# UNITED STATES PATENT AND TRADEMARK OFFICE

| APPLICATION NO.  | FILING DATE | FIRST NAMED INVENTOR | ATTORNEY DOCKET NO.             | CONFIRMATION NO.            |
|--|-------------|----------------------|---------------------------------|-----------------------------|
| 10/711,842   | 10/08/2004  | Markus Reiter        | 20067US                         | 5841                        |

| <b>Office Action Summary</b> | <b>Application No.</b><br>10/711,842 | <b>Applicant(s)</b><br>REITER, MARKUS |  |

## DETAILED ACTION

**FIG. 12**

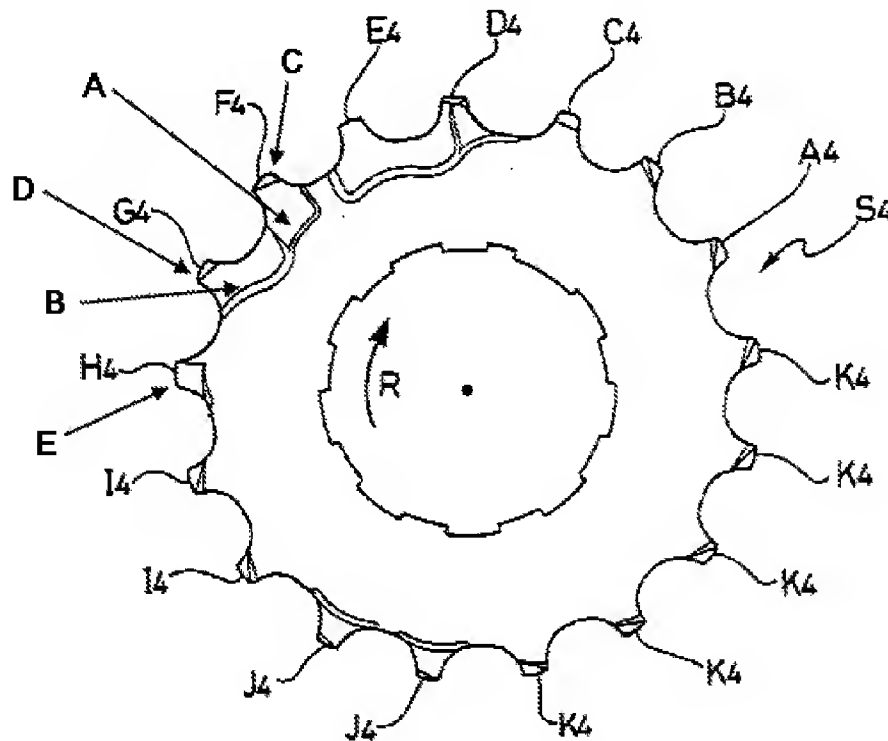
In Re claim 1, with reference to Fig. 3, 13, 14, and 12 (above), Kamada discloses a chainwheel assembly including a plurality of chainwheels (s1-s7) engageable with a chain (23) having successive alternating pairs of inner link plates and outer link plates connected by pins, the pins surrounded by rollers, the chainwheel assembly comprising: at least one smaller chainwheel (s3) having a plurality of teeth spaced about its circumference; and at least one larger chainwheel (s4) having a greater number of teeth spaced about its circumference than the smaller chainwheel, the larger chainwheel and the smaller chainwheel oriented relative to each other such that a distance between a center of the chain roller positioned between a pair of adjacent teeth on the larger chainwheel and the center of the chain roller between a pair adjacent teeth on the smaller chainwheel is substantially an integer multiple of the chain pitch, at least a first tooth (f4) of the pair of adjacent teeth (F4,G4) on the larger chainwheel includes a first lateral recess (A) having a first run-on ramp (see fig. 14), at least a second tooth (G4) of the pair of adjacent teeth disposed adjacent to the first tooth opposite the drive rotation direction including a second lateral recess (B) with a run-on ramp (see fig. 14).

In Re claims 2 and 3, see fig. 14.

In Re claim 5, see third tooth (H4) which includes a run-out chamfer (E).

In Re claim 7, see fig. 14.

In Re claims 8, 9, and 12, see deflection chamfers (C,D) on the first and second tooth (F4,G4) in fig. 12 above.

In Re claim 15, see fig. 3.

In Re claim 16, see chamfers (C,D,E).

As previously stated, in response to applicant's argument that that Kamada fails to disclose two run-on ramps configured to lift the outer link plate of a chain, a recitation of the intended use of the claimed invention must result in a structural difference between the claimed invention and the prior art in order to patentably distinguish the claimed invention from the prior art. If the prior art structure is capable of performing the intended use, then it meets the claim. In this case, the examiner believes that Kamada's recesses are understood to include run-on ramps that could lift the outer link plate of a chain as understood from the claim. Additionally, the examiner points out that the claims do not define the recesses and run-on ramps so as to define over the first and second recesses of Kamada.

**FIG. 5**

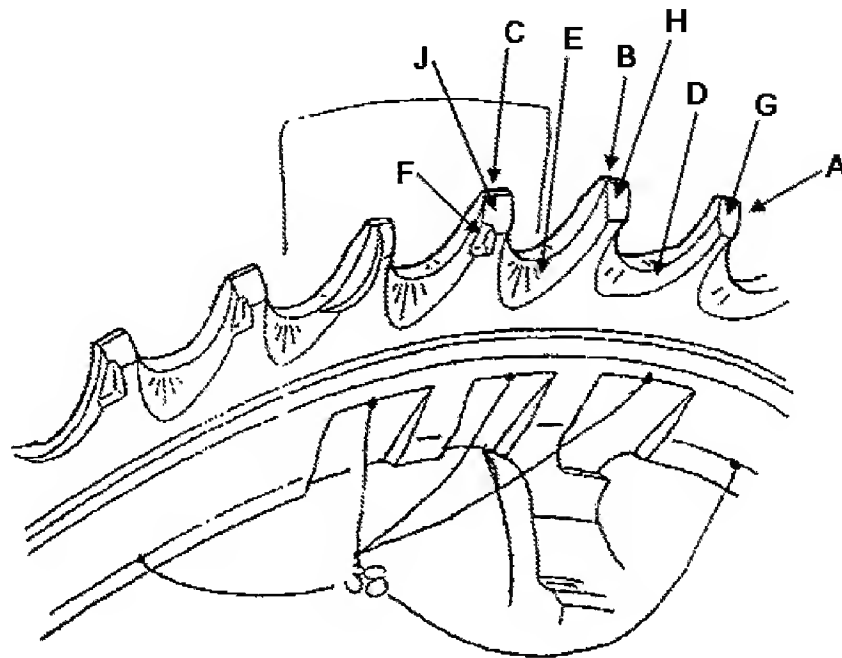
In Re claim 1, with reference to Fig. 5, above, Yahata discloses a chainwheel assembly including a plurality of chainwheels (see fig. 15) engageable with a chain (10), the chainwheel assembly comprising: at least one smaller chainwheel (50) having a plurality of teeth spaced about its circumference; and at least one larger chainwheel (40) having a greater number of teeth spaced about its circumference than the smaller chainwheel, at least a first tooth (A) of a pair of adjacent teeth (A,B,C) on the larger chainwheel includes a first lateral recess and run-on ramp (D), at least a second tooth (B) of the pair of adjacent teeth disposed adjacent to the first tooth opposite the drive rotation direction including a second lateral recess and run-on ramp (E).

In Re claims 2 and 3, see fig. 5.

In Re claim 5, see third tooth (C) which includes a run-out chamfer (F).

In Re claim 7, see fig. 5.

In Re claims 8 and 12, see deflection chamfers (G,H) on the first and second tooth (A,B) in fig. 5 above.

In Re claim 15, see fig. 11.

In Re claim 16, see chamfers (G,H,J).

In Re claim 24, the recesses are separate from each other.

As stated above, in response to applicant's argument that the recesses E and D of Yahata are not configured to lift the outer link plate of a chain, a recitation of the intended use of the claimed invention must result in a structural difference between the claimed invention and the prior art in order to patentably distinguish the claimed invention from the prior art. If the prior art structure is capable of performing the intended use, then it meets the claim. In this case, the examiner believes that Yahata's recesses are understood to include run-on ramps that could lift the outer link plate of a chain as understood from the claim. Additionally, the examiner points out that the claims do not define the recesses and run-on ramps so as to define over the recesses of Yahata.
